TO: ALL BIDDERS	FROM: Luis Ponce, P.E.
COMPANY:	DATE: August 14, 2015
ADDRESS:	TOTAL NO. OF PAGES INCLUDING COVER: 4
RE: City of Ferndale Addendum 1 MALLOY AVENUE SANITARY SEWER PROJECT PROJECT # SS2015-02

ADDENDUM NO. 1
To the Contract Provisions for
CITY OF FERNDALE, WASHINGTON

MALLOY AVENUE SANITARY SEWER PROJECT
PROJECT #SS2015-02

Plan Sheet 5

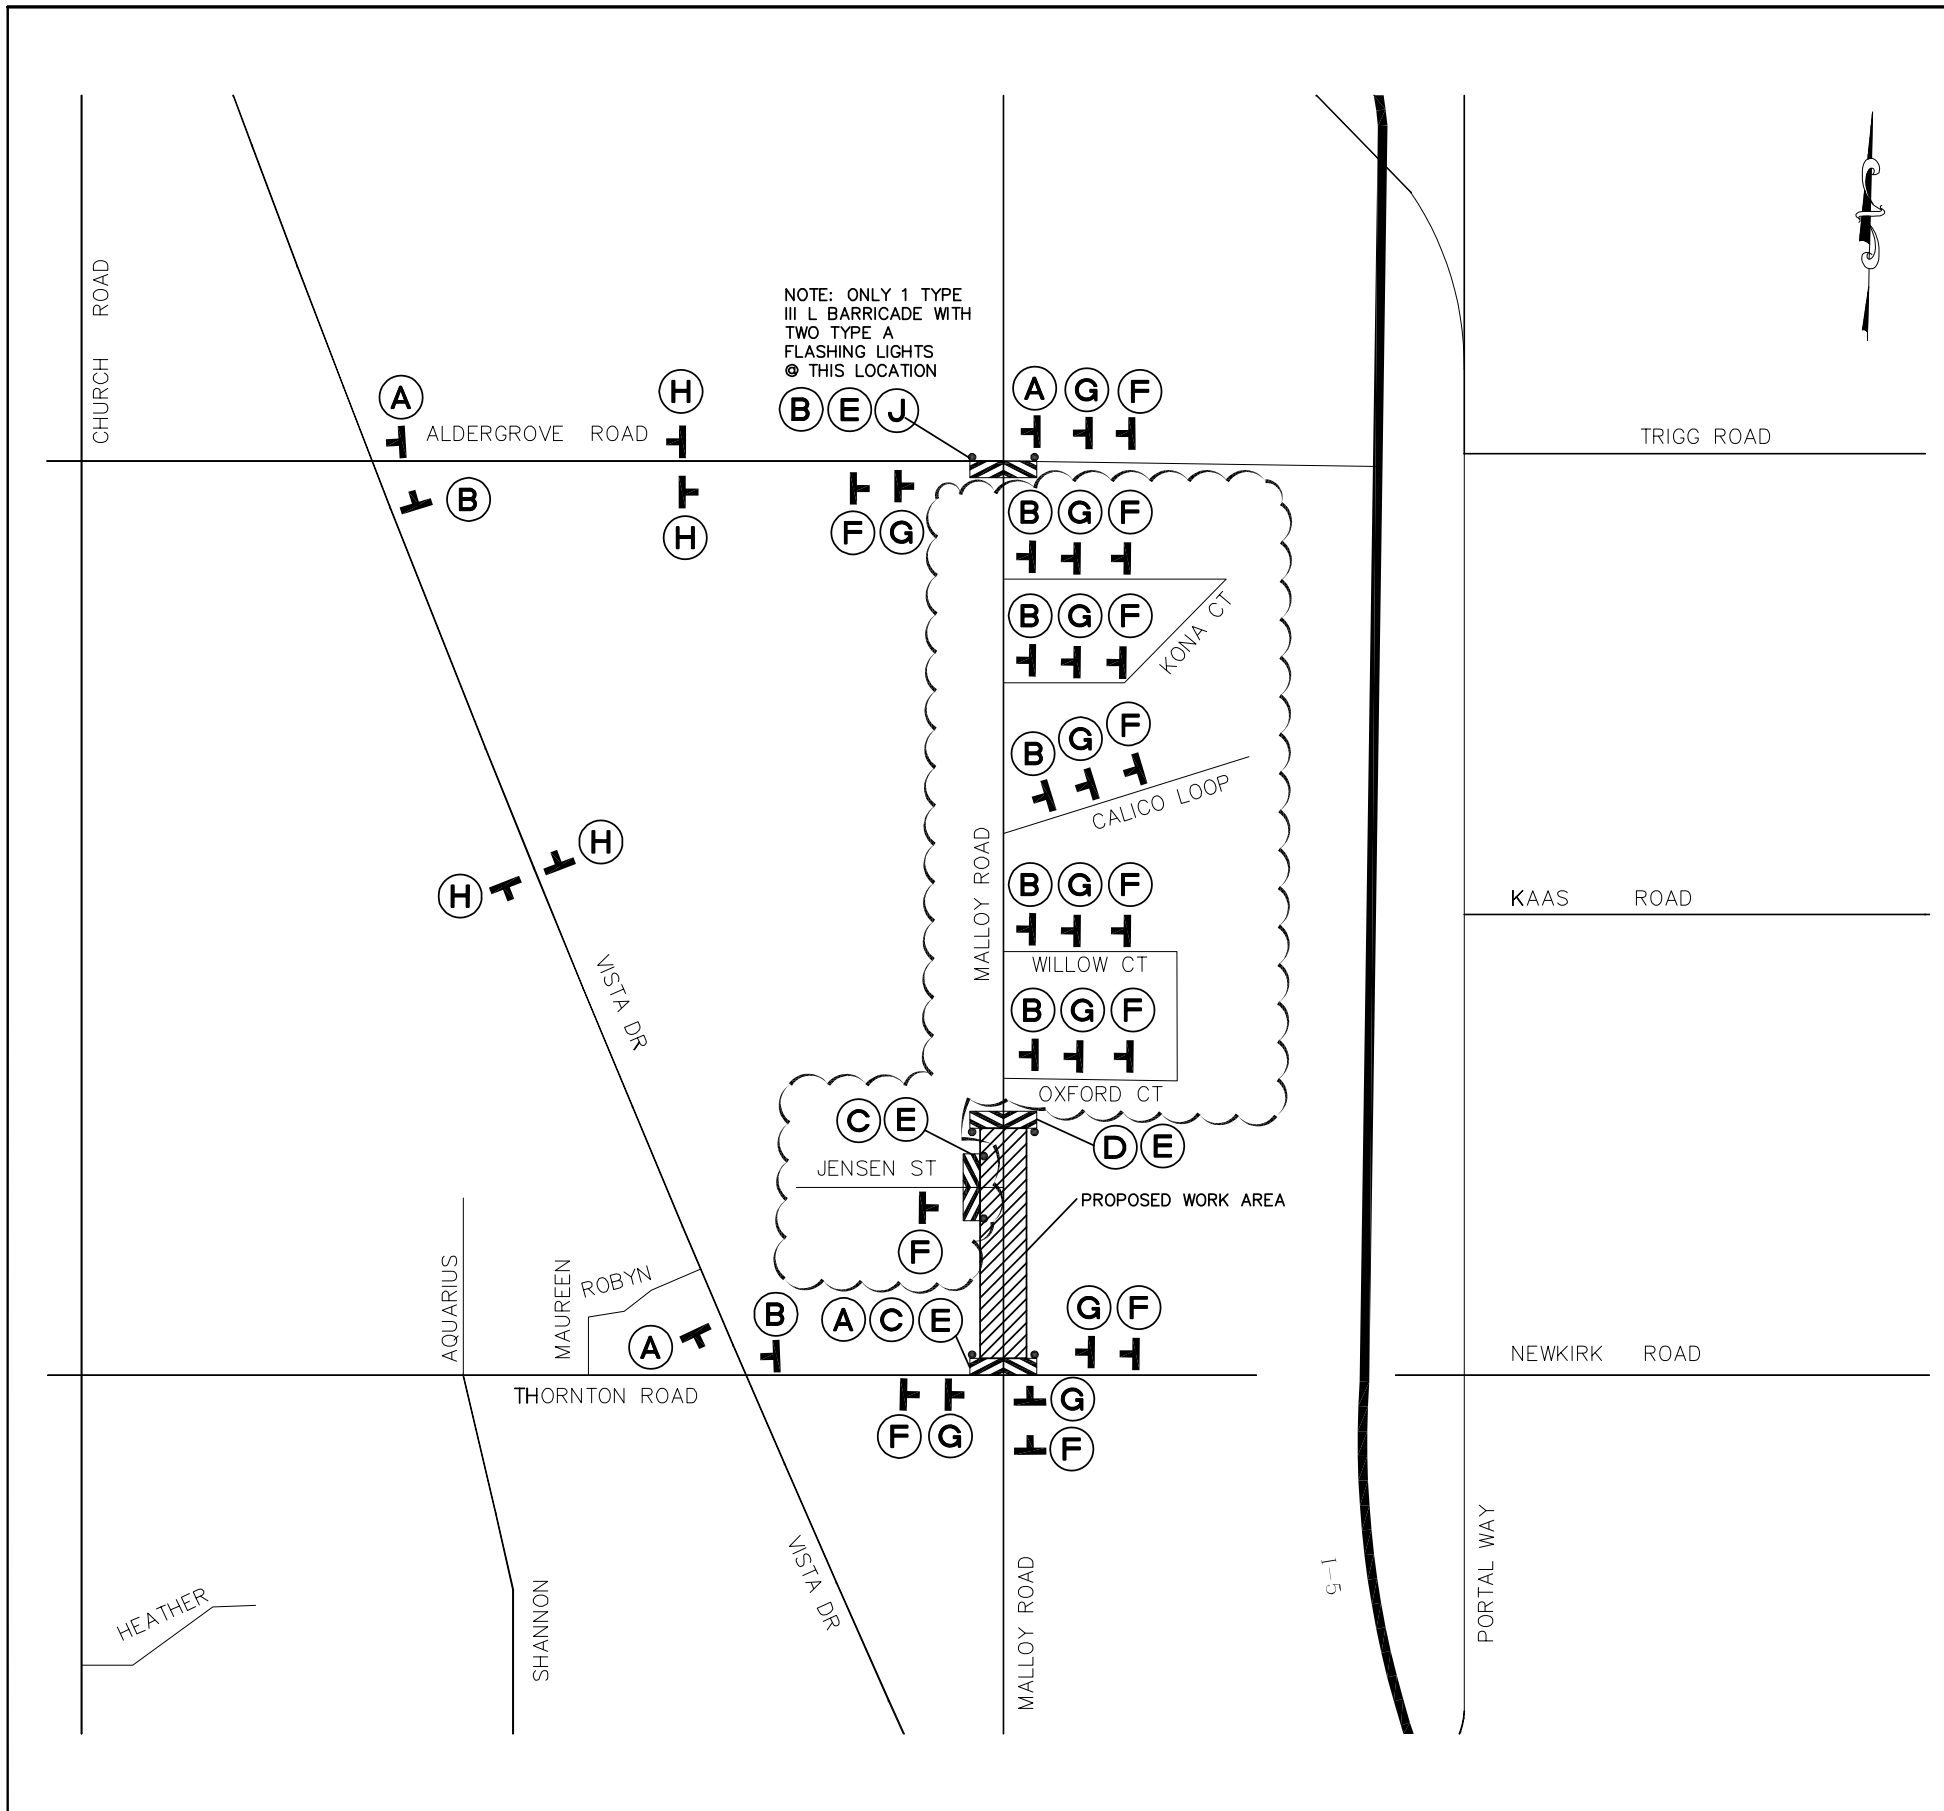
Additional signage was added.

NOTE: ONLY 1 TYPE III L BARRICADE WITH TWO TYPE A FLASHING LIGHTS @ THIS LOCATION
